FILE #: SI-2023-00207 PROJECT #: PR-2019-002677

Carlisle Crossing Site Redevelopment

RE: PROJECT – 2100 CARLISLE BLVD NE CORNOR OF CARLISLE BLVD & INDIAN SCHOOL RD NE (FORMER KMART SITE) – ALBUQUERQUE, NM. 87110

ADMINISTRATIVE AMENDMENT TO SITE PLAN FOR BUILDING PERMIT

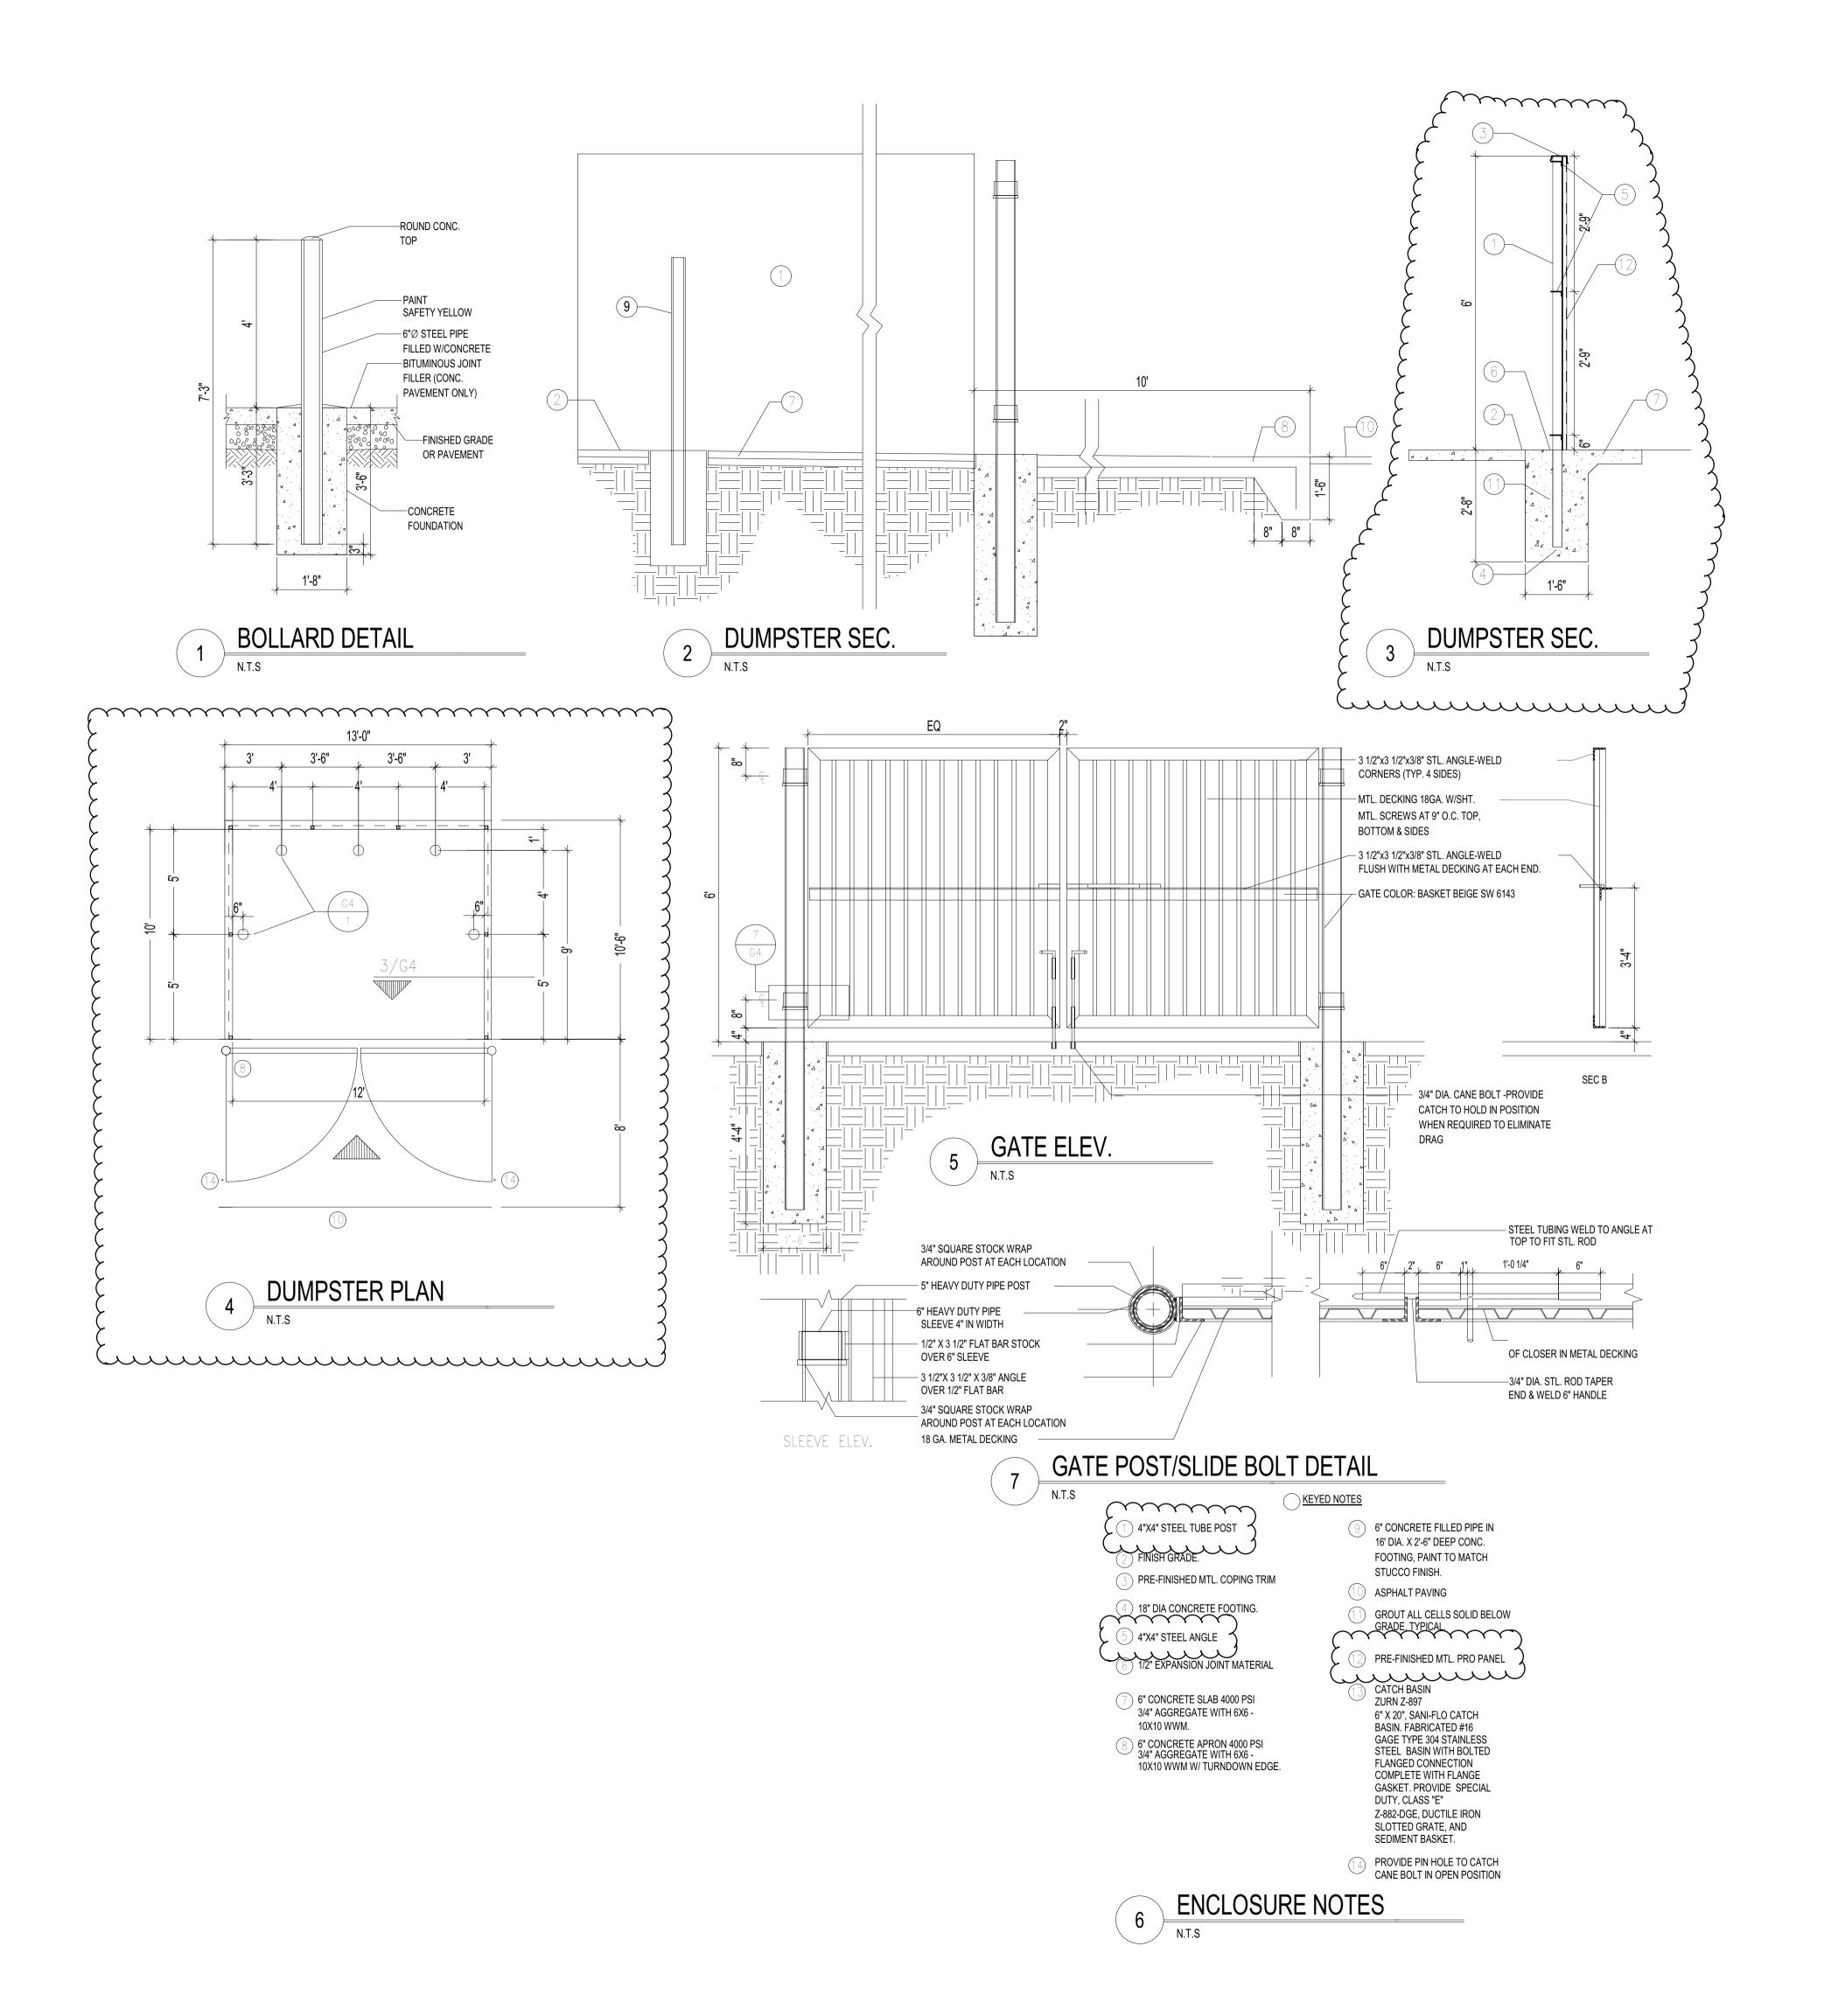
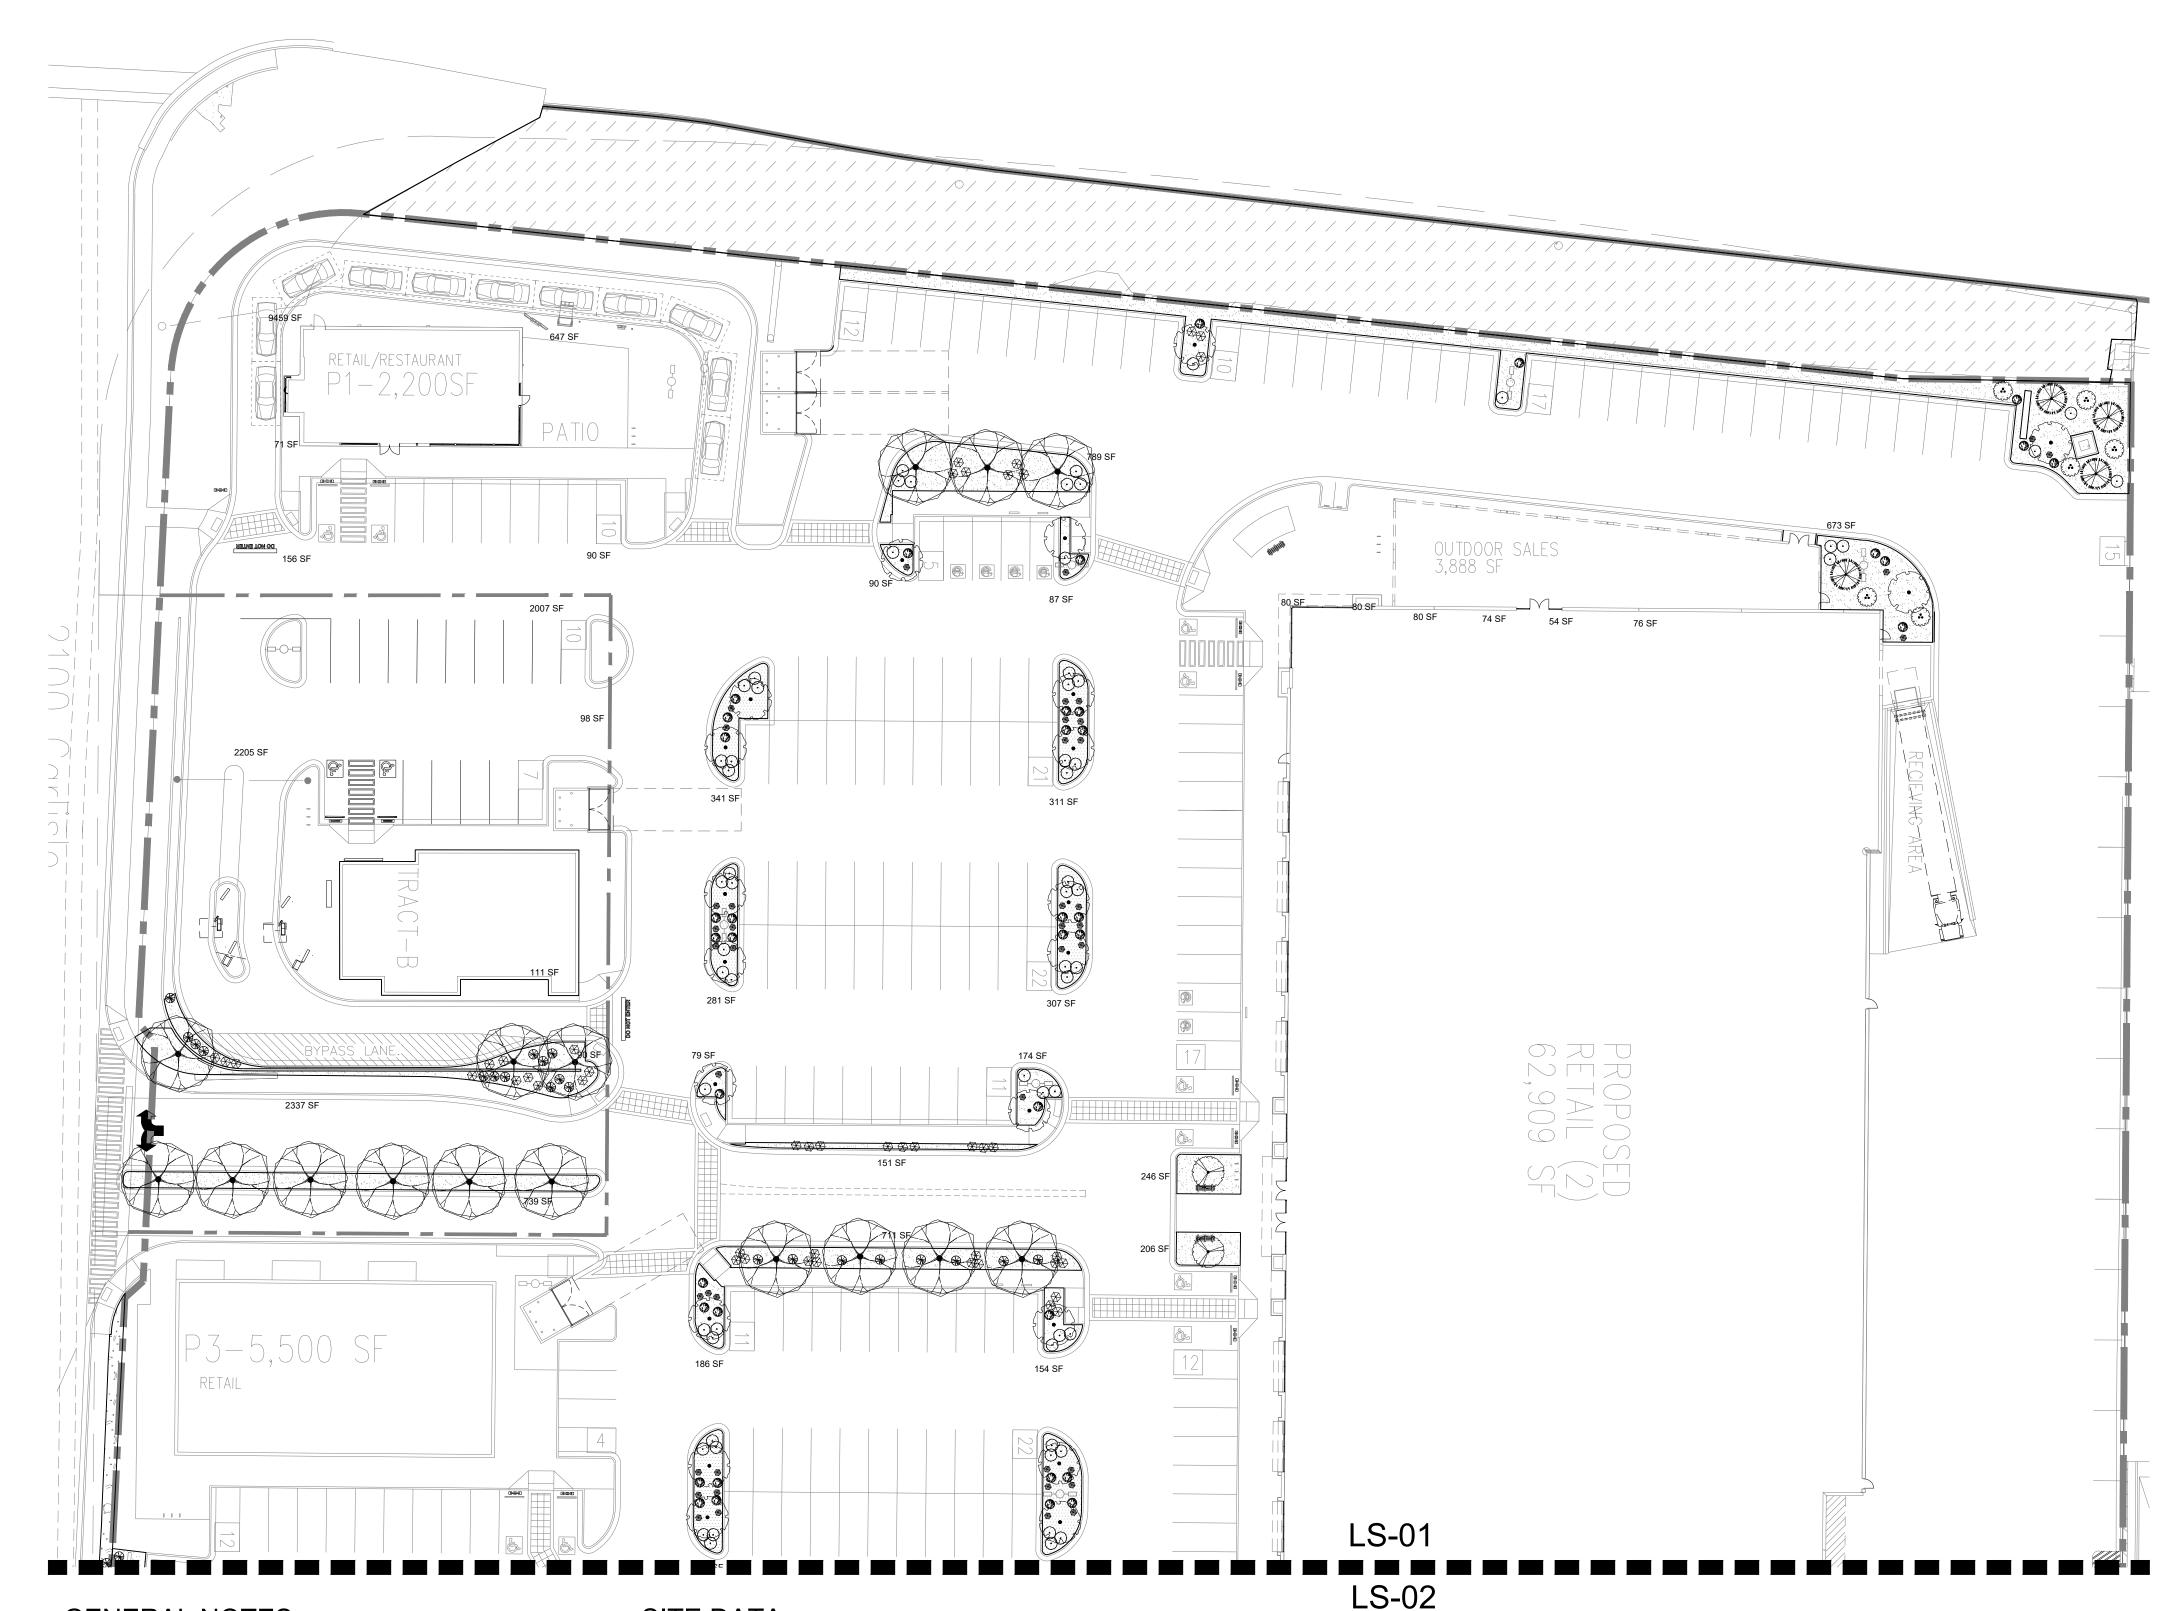
Elevation Plan:

- 1. The elevations have been modified only on the American Home Furniture user. The north, east and west façades have been modified per the changes below.

- a. The outdoor patio was originally showed in the prior AA. We are proposing and enclosure around the patio per the elevations.
 - b. The northwest corner of the proposed retail pad (American Home) has been modified. The glass have been removed and it will be completely stucco.

- c. The north elevation has been modified. The panels have been removed and replaced with CMU.
 - i. There is a glass door added.
 - d. The west elevation shows the modified enclosure around the patio.

- 2. All material and colors are called out on the new elevation plan.
- 3. Façade Requirements 14-16-5-11(E)
 - a. According to the IDO each street facing façade within 30 ft. of a property line (the measurement shall be made to the closest perpendicular plane of a primary building façade) has to follow 14-16-5-11(E). All the street facing facade exceed 30ft from the property line as a result 14-16-5-11(E) is not applicable.

Landscape Plan

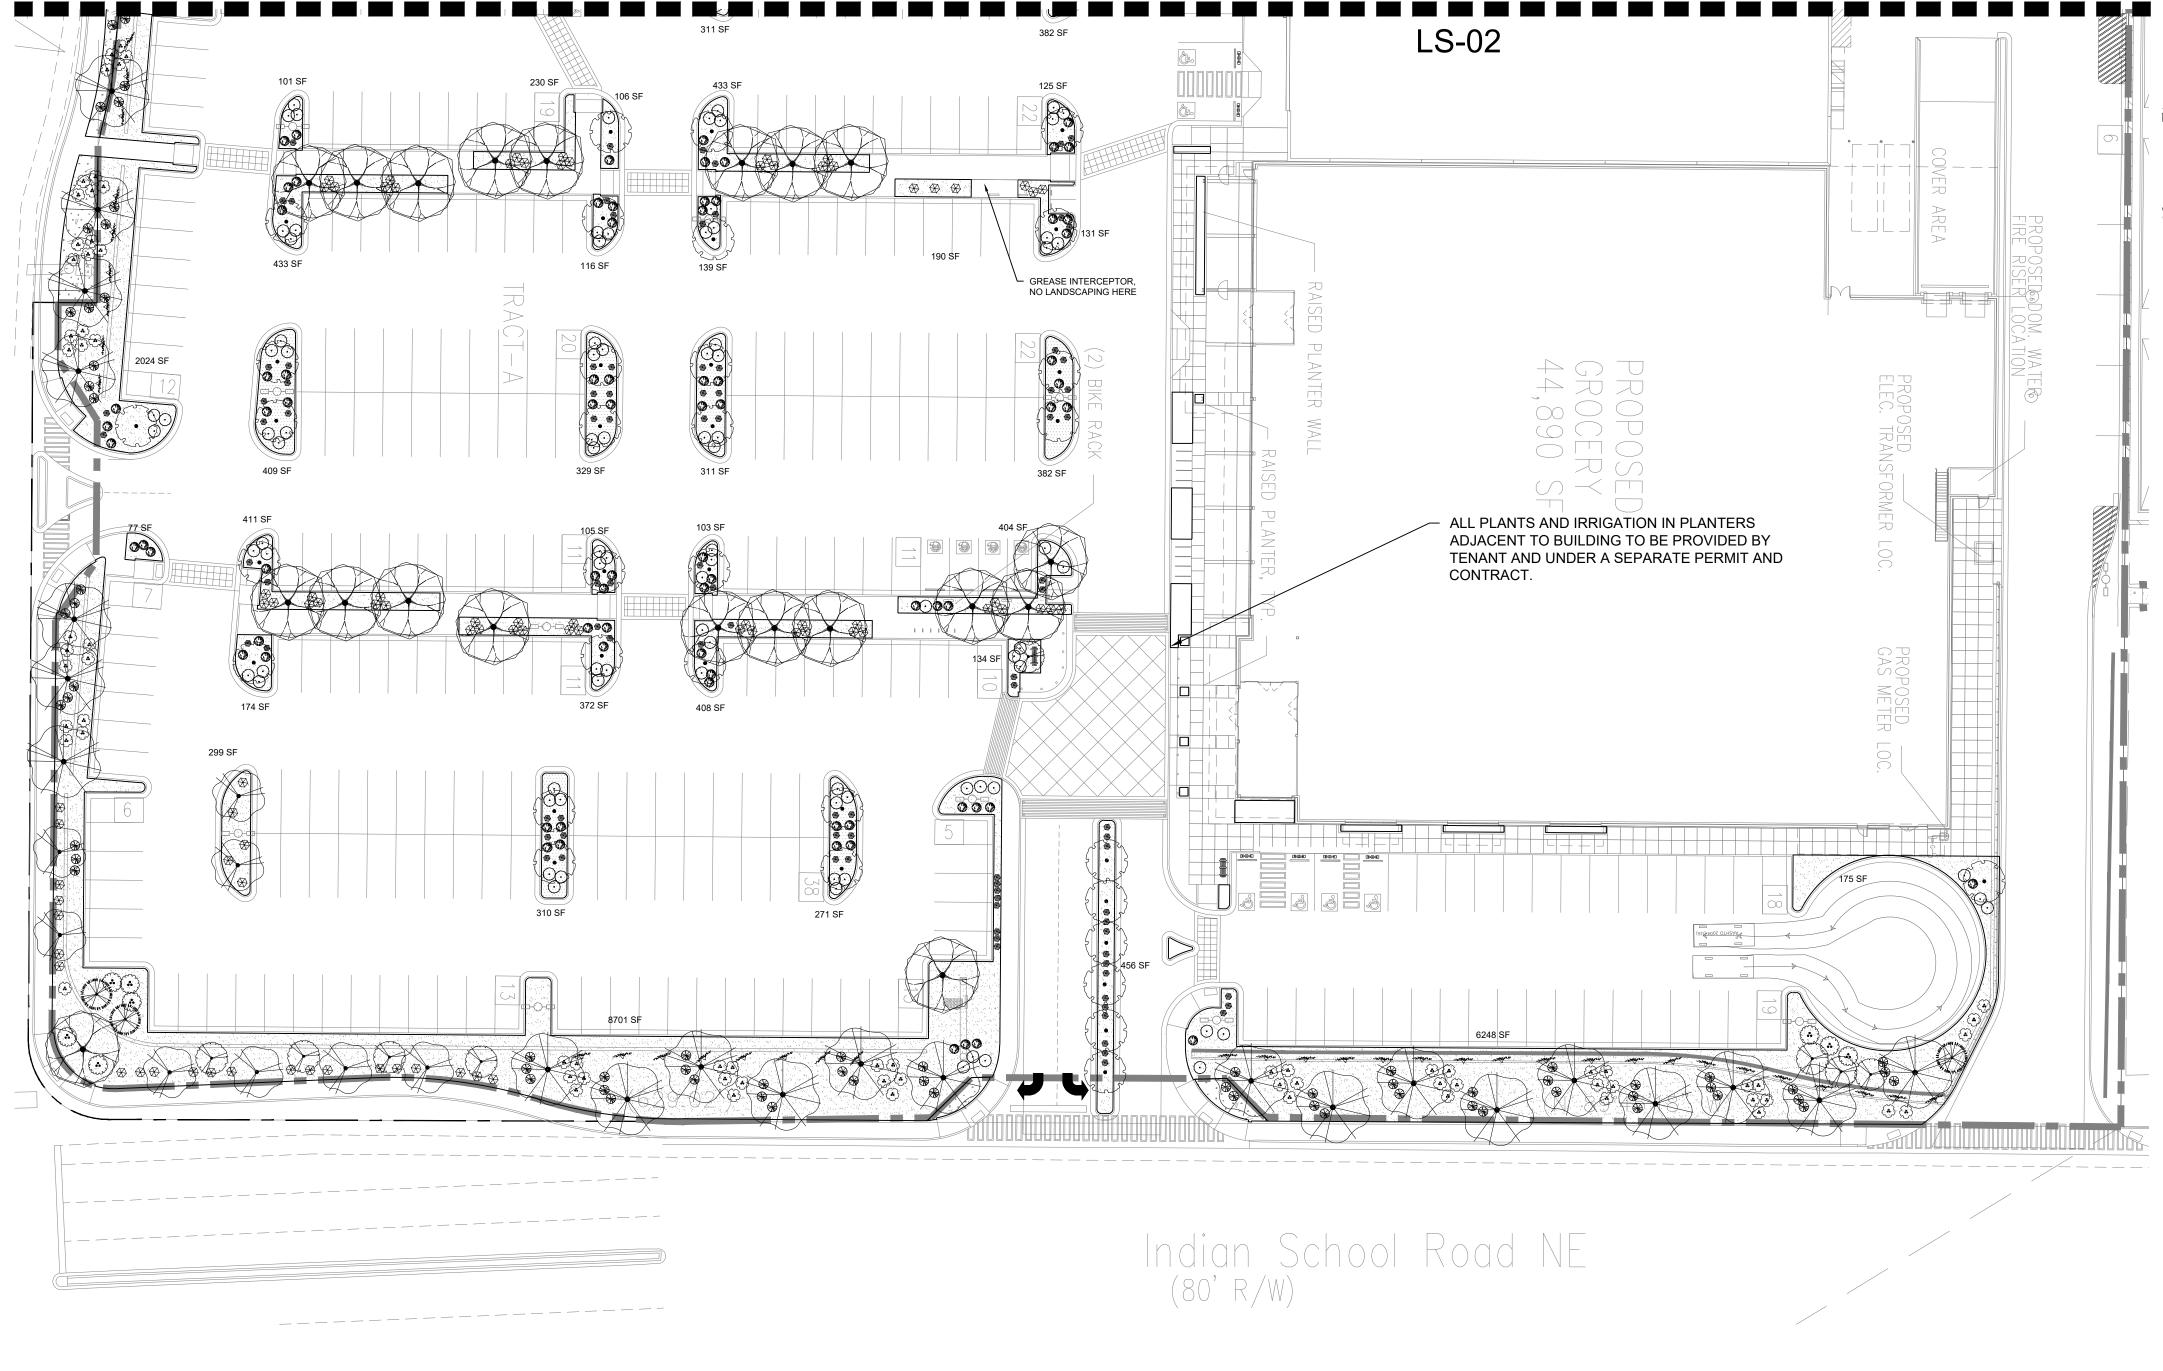
Landscaping Plan:

- 1. A Landscaping Plan has been modified to accommodate the changes to the Site Plan.
- 2. The landscape species have been updated to reflect the current market and availability. Below are the listed species that changed.
 - a. Desert Willow/Vitex reduced to 15 gallon size
 - b. Elm changed to Allee Elm due to availability
 - c. Honeysuckle/Rosemary changed to 1 gallon size
- 3. All changes meet the IDO and the DPM standards. We have not created a deficiency in the landscaping requirements and that is demonstrated on the Landscaping Plan.
